TO: PARCEL 15 (PORTAC) CLEANUP PHASE 1

SUBJECT: RFP NO. 071579

ADDENDUM NUMBER # 02

PIPE CONNECTION DETAIL
SCALE: N.T.S.

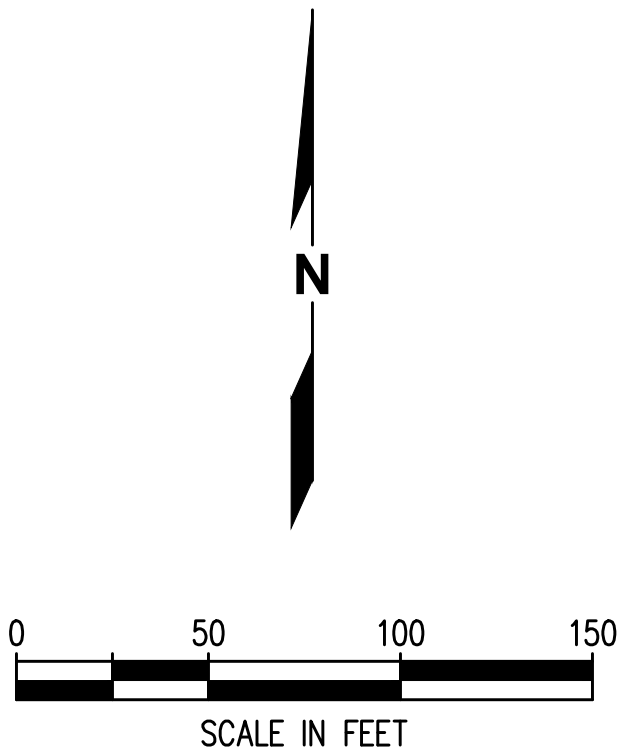
1. Attachment A-Storm Drain Plans

- WHEN THE COUPLING BAND CONNECTION REQUIRES ATTACHMENT TO THE BELL END OF A CONCRETE PIPE, THE BELL END OF THE PIPE SHALL BE REMOVED BEFORE THE CONNECTION IS INSTALLED.
- INCREASE THE OUTSIDE DIAMETER OF THE CORRUGATED POLYETHYLENE PIPE TO MATCH THE OUTSIDE DIAMETER OF THE CONCRETE PIPE BY INSTALLING 12" WIDE RUBBER GASKETS, THICKNESS AS REQUIRED (COUPLING BAND ONLY). THE RUBBER GASKETS SHALL BE CONTINUOUS CLOSED CELL, SYNTHETIC EXPANDED RUBBER GASKETS CONFORMING TO THE REQUIREMENTS OF ASTM D1056, GRADE 2B3.
- USE THE FLAT TYPE K COUPLING BAND. TYPE K COUPLING BANDS WITH DIMPLES ARE NOT ALLOWED FOR THE INSTALLATION DETAIL SHOWN. THE COUPLING BAND OPTION SHALL ONLY BE USED FOR EXTENDING EXISTING PIPES THAT HAVE AN INSIDE DIAMETER OF 36" OR LESS.
